Re: 49 CFR Part 573; Recall of Mercedes-Benz SLK (170) Tail Lamps

Re: Recall Campaign 2006080005 - Replace Tail Lamps, Model 170 Model Year 1998 - 2000

TO: ALL MERCEDES-BENZ CENTERS
SUBJECT: **MODEL 170, MODEL YEAR 1998-2000
REPLACE TAIL LAMPS**

Figure 1

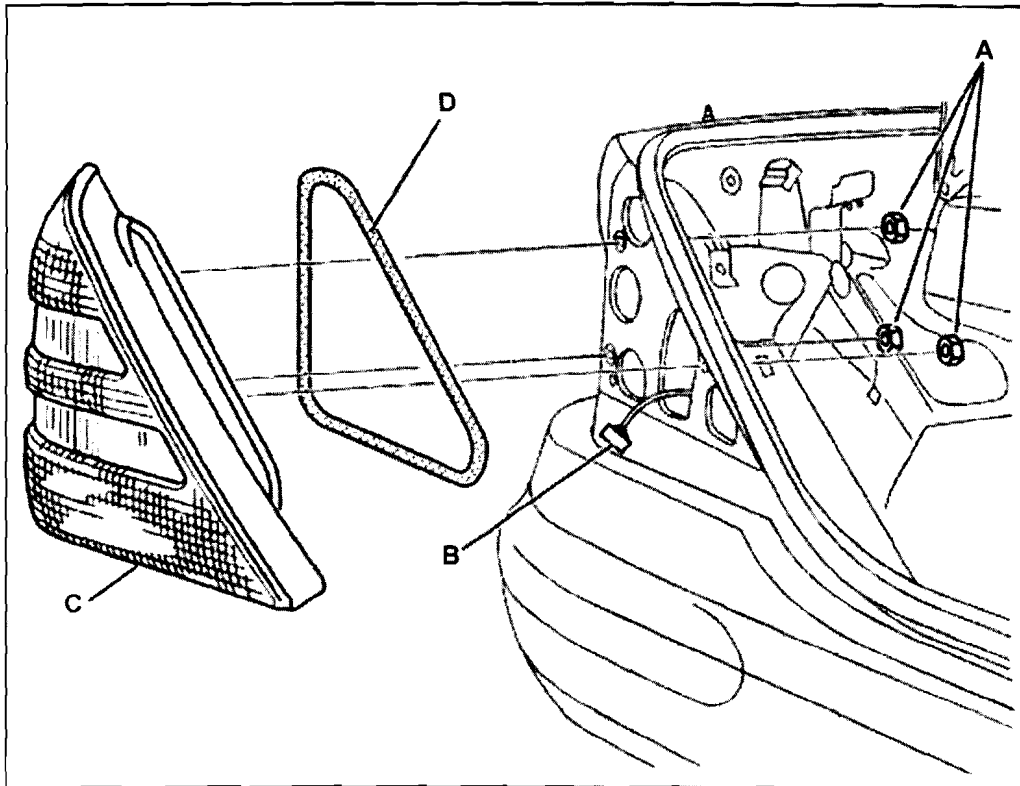
This Recall Campaign has been initiated because DCAG has determined that due to the heat generated by the brake lamps of the affected vehicles (see VIN range on the following page) the base of the lamp socket can be subject to thermal deformation over time. This deformation can cause movement in the socket-to-bulb connection, which may lead to a loosening of the electrical contacts in the sockets and a failure of the bulb to illuminate. This can cause a failure of either brake light (the center brake light is not affected). A failure of the brake lamp bulbs to illuminate could lead to a rear end vehicle crash. Dealer will replace all rear lamp modules in affected vehicles with new rear lamp modules redesigned with a more heat resistant material, different bulbs, and enhanced lamp holder mountings. Dealer will also place a label in the vehicle operator's manual indicating new bulb part number assignment.

1. Open trunk lid.
2. Remove first-aid kit on left side; remove flap in wheelhouse paneling and CD changer (if applicable) on right side.
3. Remove nuts (A, Figure 1).
4. Disconnect electrical connector (B).
5. Replace tail lamps (C) on both sides of vehicle.

Ensure to install and position seal (D) correctly when installing new tail lamp.

This Recall Campaign affects approximately 32,618 MY 1998 - 2000 vehicles in the U.S. The repair time for this campaign is 0.5 hours. All rear lamp modules in affected vehicles will be replaced with redesigned rear lamp modules. The new module has been designed with a more heat resistant material, different bulbs, and enhanced lamp holder mountings. A label will also be placed in the vehicle operator's manual indicating new bulb part number assignment.

Figure 2

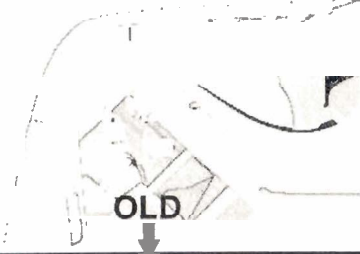
7. Place new sticker over previous lamp specifications in Operator's Manual as shown in Figure 2 for Model Years 1998-2000.
